Nebraska Public Power District

NLS2000075

Subject: Proposed License Amendment
Cooper Nuclear Station, NRC Docket 50-298, DPR-46

Title: Removal of Railroad Tracks from Figure 4.1-1, Site and Exclusion Area Boundaries and Low Population Zone.

Figure 4.1-1 (page 1 of 1)
Site and Exclusion Area Boundaries
and Low Population Zone

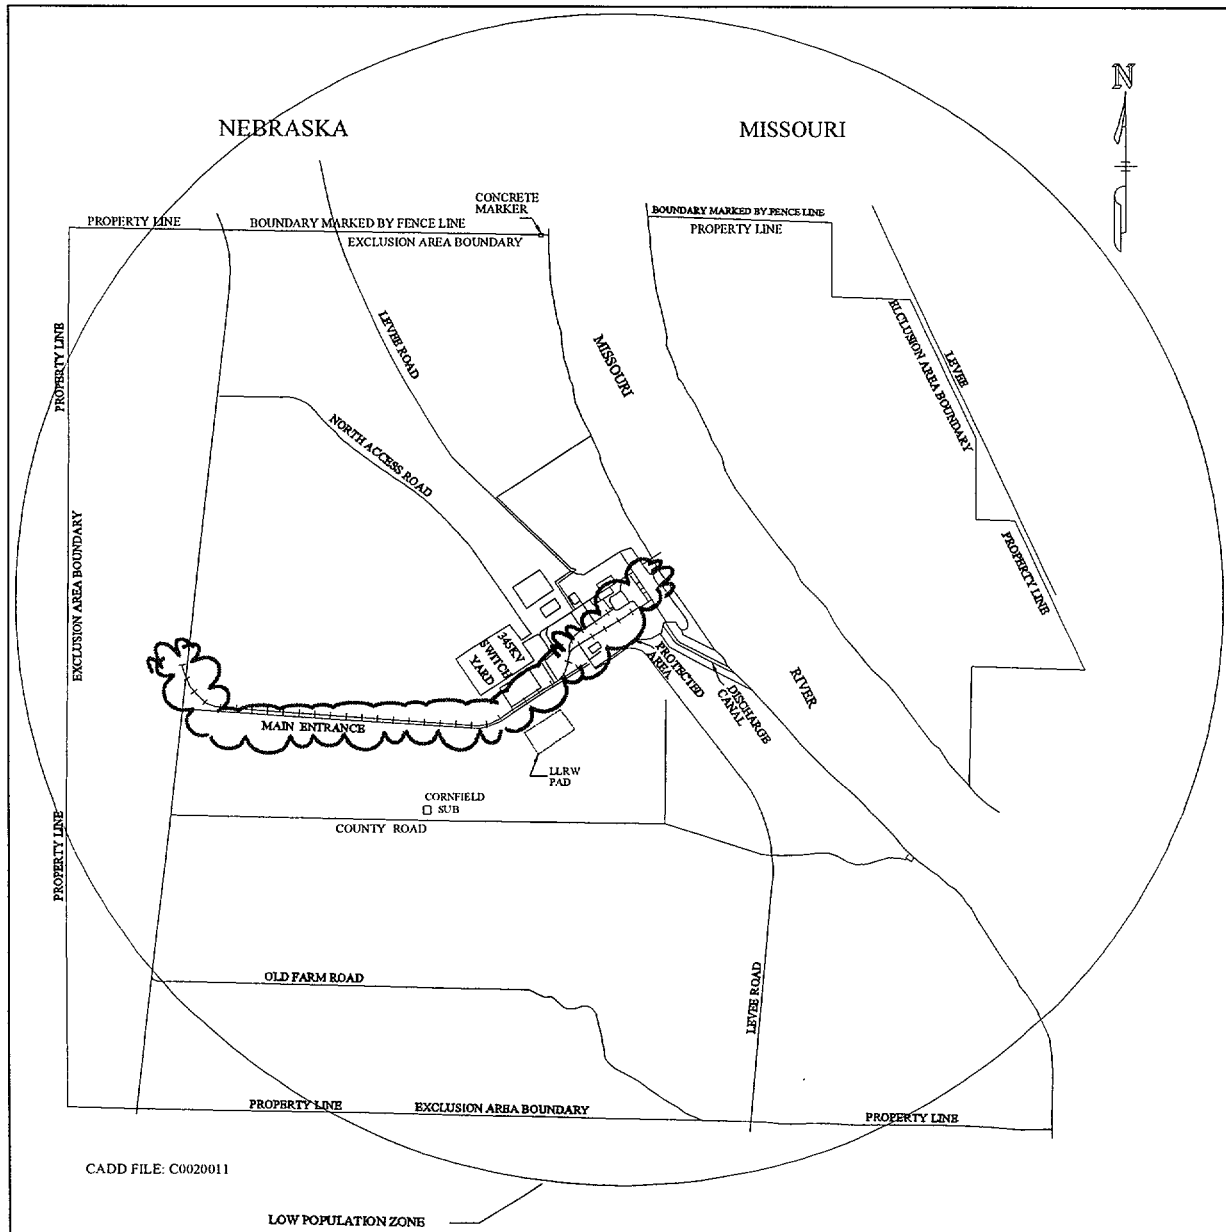
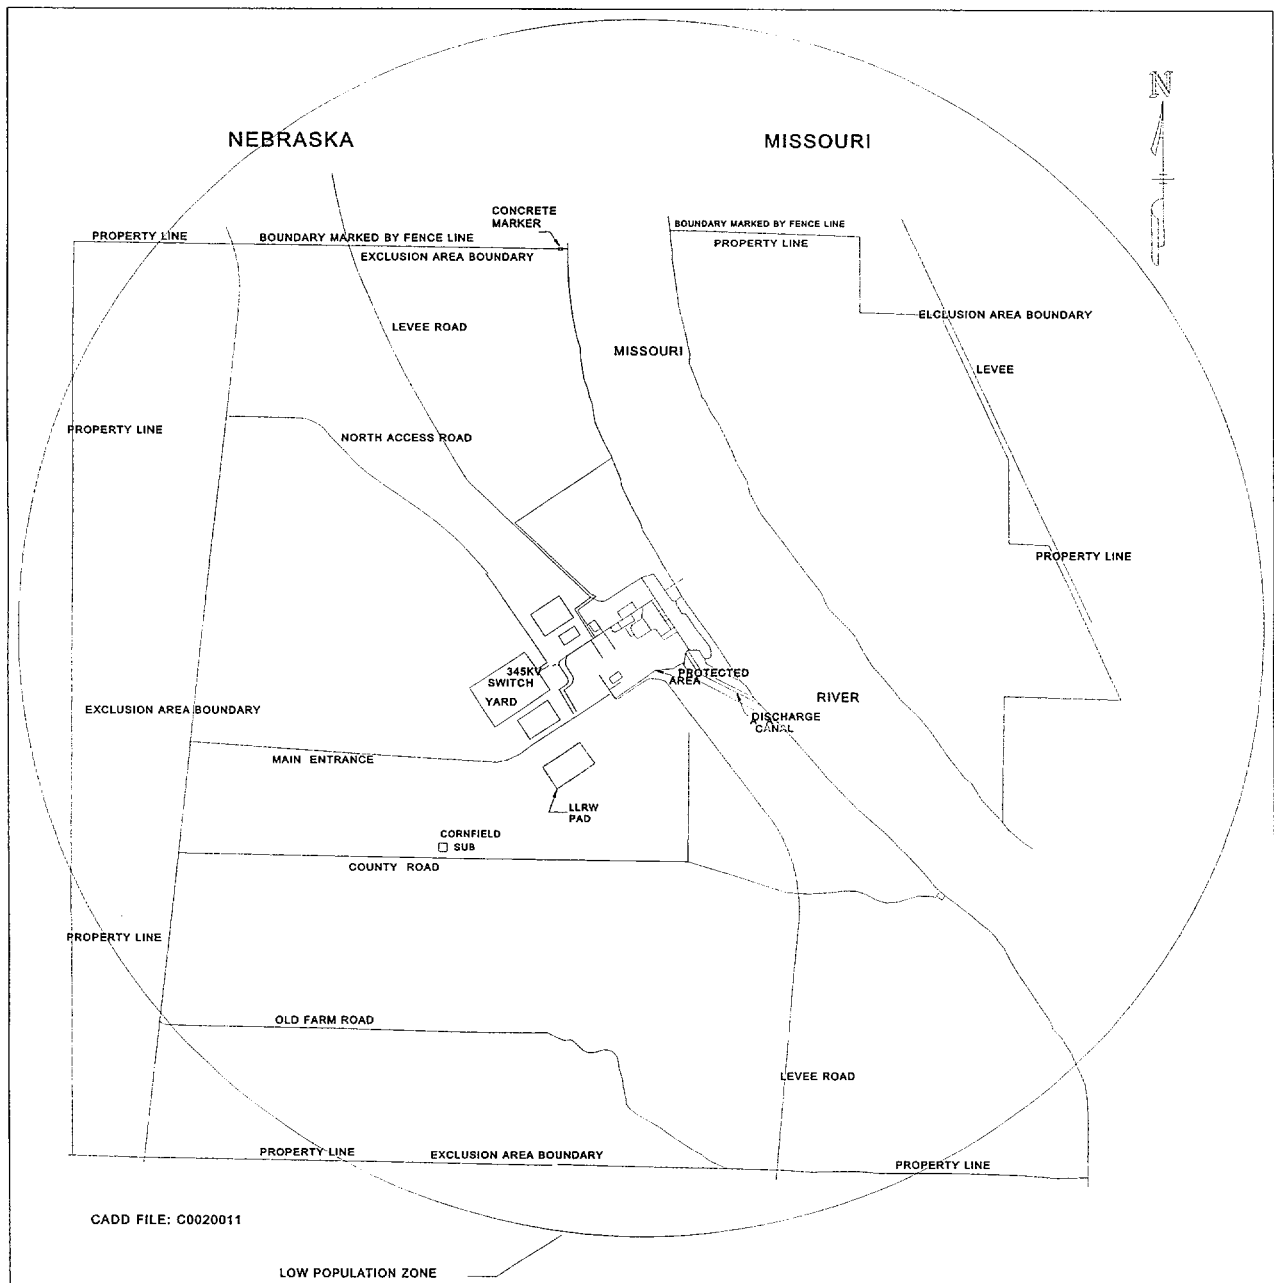
The proposed change would revise Technical Specifications Figure 4.1-1, "Site and Exclusion Area Boundaries and Low Population Zone" for Cooper Nuclear Station (CNS) to remove the depiction of railroad tracks along the main entrance road and into the plant and would change the text font within the figure for readability.

The rail line depicted in Figure 4.1-1 (Attachment 5) is a spur from the rail line to the CNS site used to provide transportation of heavy freight into and from the site which has since been abandoned in place. The figure shows the rail line next to the Main Entrance road as a cross hatched line which then splits into 3 branches that cross the Protected Area perimeter. The rail line is no longer used and serves no plant operational or safety function. Thus, it adds no significant information to the figure. This change proposes to remove depiction of these tracks from Figure 4.1-1. To improve readability,

especially for photocopies, this change also proposes to change the font of text within the figure to lettering without serifs. The proposed annotated TS page change, and final revised figure are included as Attachments 5 and 6.
